RE: Ventris Place (P17-041) Rev 1

WALKSacramento has reviewed the revised project routing for Ventris Place (P17-041). Our letter commenting on the original routing recommended revising private drive cross section C-C such that universal access for pedestrians is provided to lots 25, 26 and 31-38. The revised project plans are nearly the same in the area of concern, except that lot 38 has been eliminated, lot 31 has a different house plan, and many of the lot widths have changed slightly. The pedestrian environment has not changed, though.

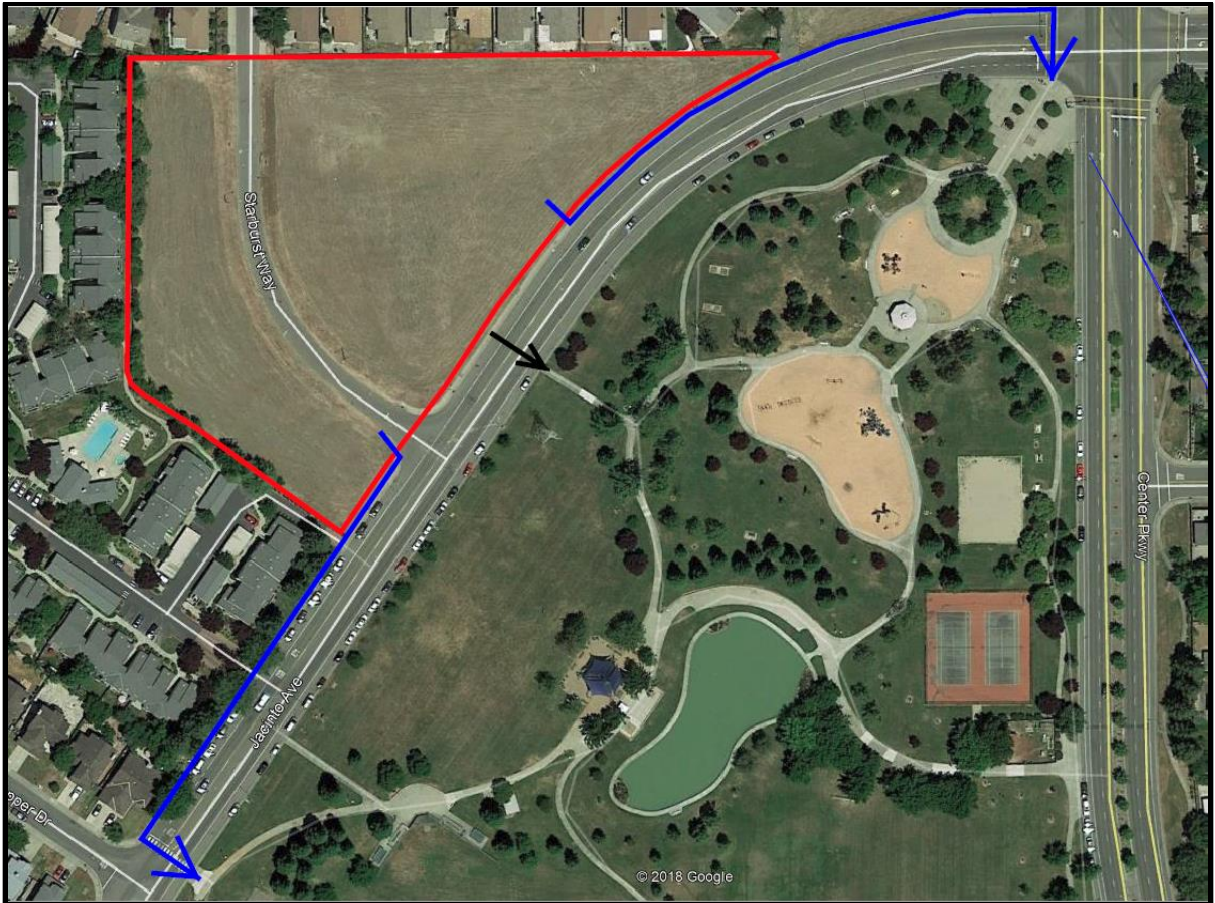
It appears that many of the lots will have small private yards, many of which are 8'- to 10'-wide side yards, and some lots will not have direct access from the house into the fenced-in yard. The front porches facing the street are not generously sized, although about two-thirds of them will be large enough for a few people to sit and/or stand. Outdoor common space hasn't been provided, either. This lack of outdoor private and common open space may create greater usage of North Laguna Creek Park directly across Jacinto Avenue from the project site. However, the two existing pedestrian crossings are each almost 600 feet from walkways into the project site. There will be desire paths across Jacinto Avenue to the park at Starburst Way and at the paseo/EVA, but there are no legal pedestrian crossings at those places. About 100' from Starburst Way, there's a sidewalk from the San Jacinto Ave curb to the activity areas in the park which will contribute to the desire lines. We encourage the applicant to work with the City to plan for a safe crossing to the park. The following diagram shows the project site outlined in red,

existing pedestrian routes to park entrances in blue, and the sidewalk into the park nearest the project site in black.
